ADVISORY NEIGHBORHOOD COMMISSION 7D

May 8, 2018

April 26, 2018: DDOT revises proposal, eliminates safety measures and neglects community input

Annex II: 65% Design presented by Volkert Inc., Ferbaury 2018

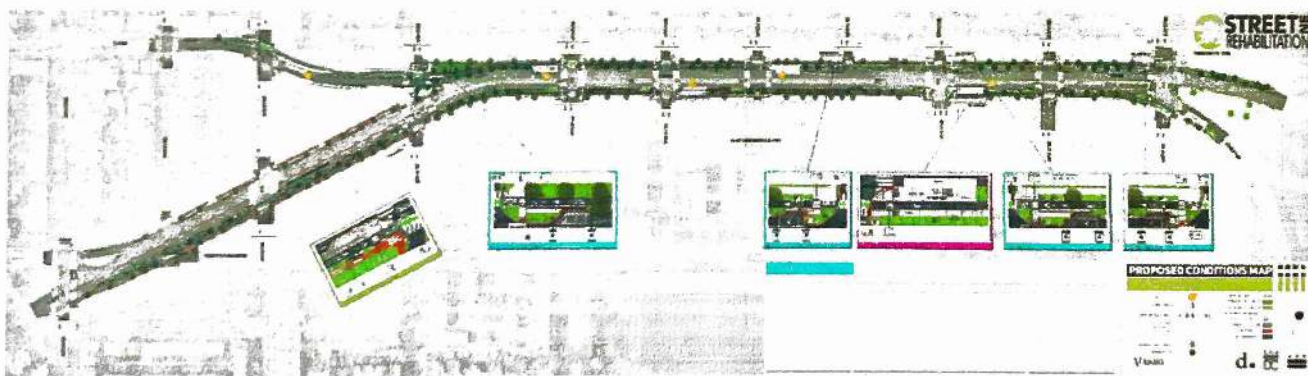
It is critical that DDOT includes all curb extensions (bulb-outs), raised cross walks, protected cycle tracks, lane reductions in both directions throughout the corridor, parking, and disabled parking, as represented in the 65% design from Volkert, Inc (see Annex II).

The Commission urges DDOT to maintain all access to full-time parking as presented in the 65% design by Volkert Inc (February 2018).

The Commission urges DDOT to maintain all raised crosswalks, as presented in the 65% design by Volkert Inc (February 2018), in any designs going forward.

FIGURE 4. WESTBOUND C STREET NE AUTO SPEEDS

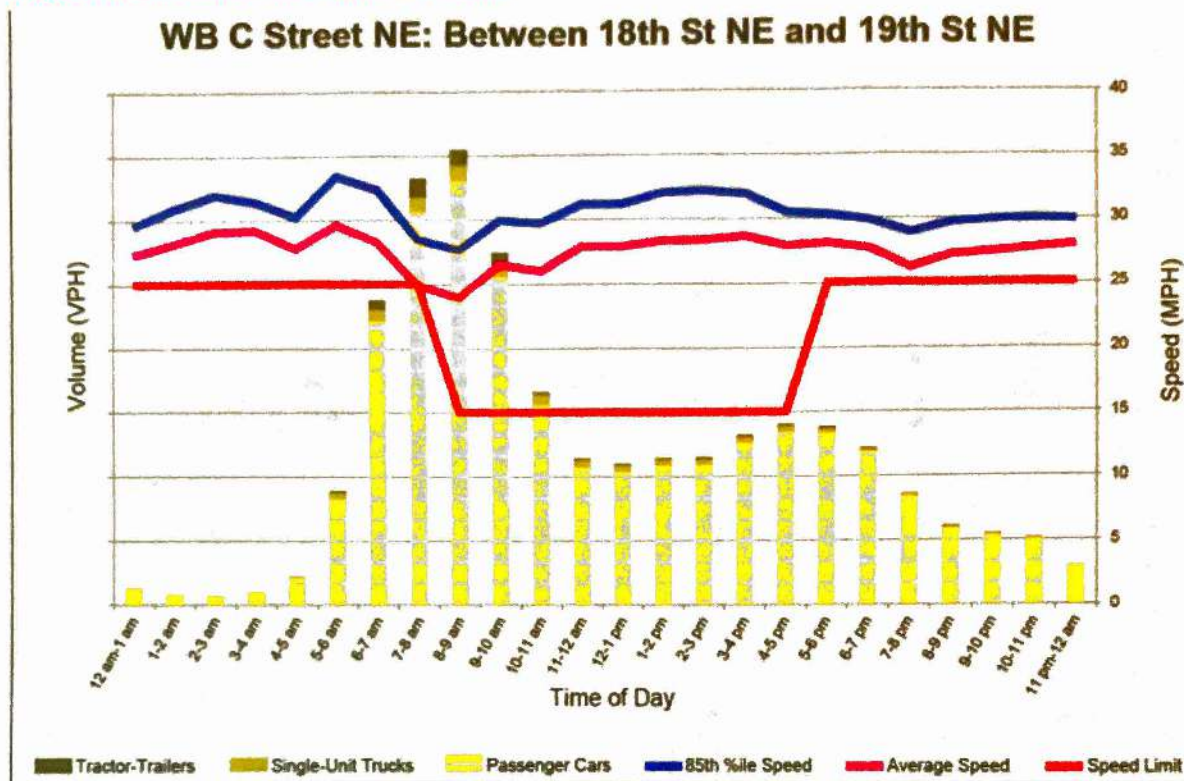
Figure: "For westbound traffic between 18th and 19th Street, motorist speeds appear to not be affected by the 15 mph speed limit during school hours and in some cases are actually higher than many non-school hours."
